NOVEMBER 19, 2024

RE: TRANSPORTATION IMPACT ASSESSMENT UPDATE LETTER
6160 THUNDER ROAD AND 5348 BOUNDARY ROAD
CITY OF OTTAWA

This update letter was originally submitted in August 2024. Following receipt of agency comments dated October 25, 2024, from Josiane Gervais via Stephan Kukkonen, this update letter was updated to address the transportation related comment from the City, which is outlined below with Crozier's response:

Drawn By	I.A.	Design By	Project	1909-5772
Check By	R.L.	Check By	P.A.	Scale 1:750
				Drawing T100

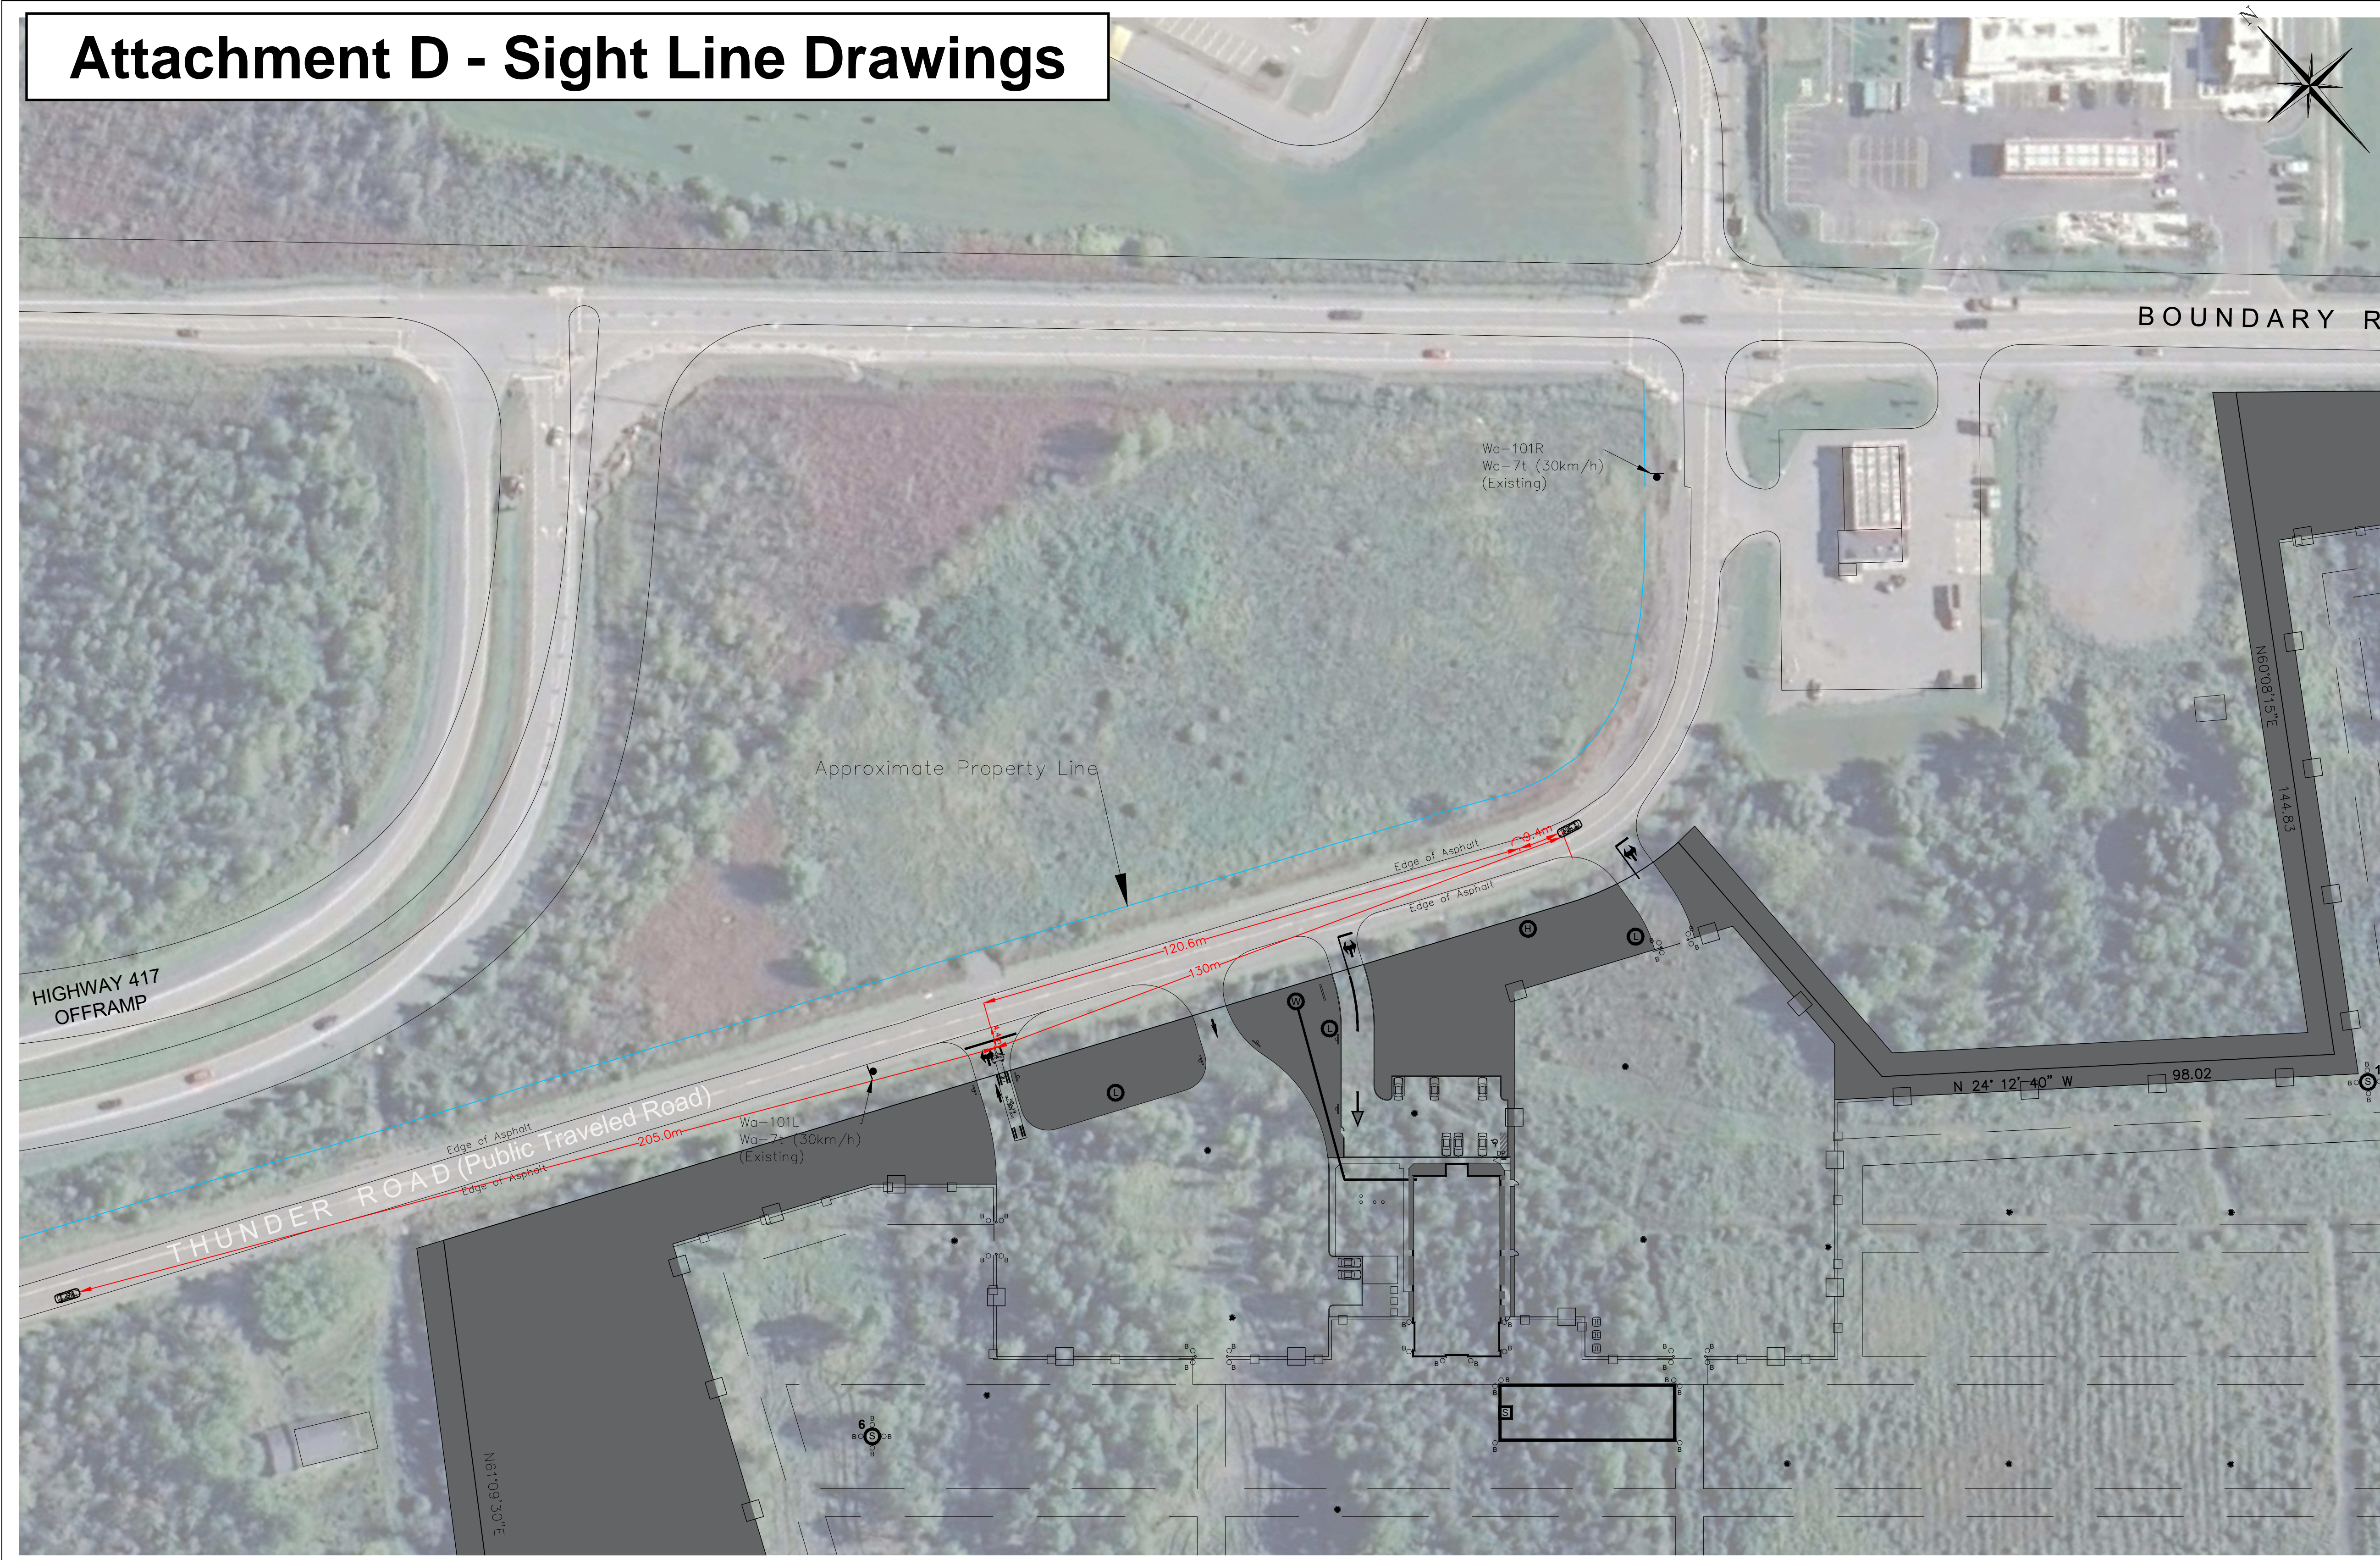
Attachment D – Sightline sketches: The sightline analysis assumes that the property across the street will remain vacant and free of development and vegetation. Because a significant portion of the site across the street is utilized for the sight-lines analysis, staff have concerns that future development will impact these sightlines. Review sight-line analysis assuming a hypothetical development of the 6165 Thunder Rd property (i.e. show property lines and building setback lines as per zoning on the plan) and identify available sight distances under a future time horizon.

- 2.3. Attachment D – Sightline sketches: The sightline analysis assumes that the property across the street will remain vacant and free of development and vegetation. Because a significant portion of the site across the street is utilized for the sight-lines analysis, staff have concerns that future development will impact these sightlines. Review sight-line analysis assuming a hypothetical development of the 6165 Thunder Rd property (i.e. show property lines and building setback lines as per zoning on the plan) and identify available sight distances under a future time horizon.

Please also note the 30km/hr warning signage for the curve on Thunder Rd on the plan for context and in support of the reduced speeds assumed for the sightline analysis. The revised plans can be submitted with the application.

Crozier Response: Crozier coordinated with the City and prepared updated sight line figures presented in **Attachment D.**

Attachment D contains updated sketches of the sight lines to demonstrate the visibility requirements and available visibility from the proposed site accesses.
